## Technical Car Construction Regulations Summary of Change Proposals for 2018 and Beyond

**Version 1.2 (Published) – 29<sup>th</sup> July 2017**

**Document compiled by: Adrian Blackwell  
BriSCA F2 Chief Technical Consultant**

### 8. Diagonal Cross-Bracing

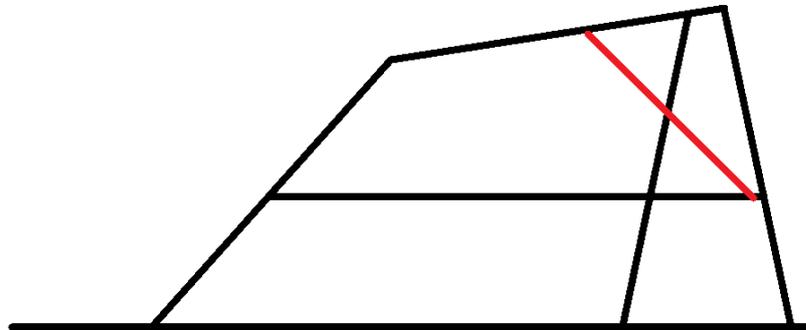
ALL roll-cages to include in their construction a diagonal cross-brace from the top of the roll-cage on each side of the car down to the chassis-rail on the opposite side (effectively a large “X” frame when viewed from the rear), to a MINIMUM specification of 30mm CHS/SHS x 3mm wall thickness. These diagonal cross-braces would be permitted to intersect each other in the middle, and are designed to reduce side-ways deformation of the roll-cage in any impact from the side.
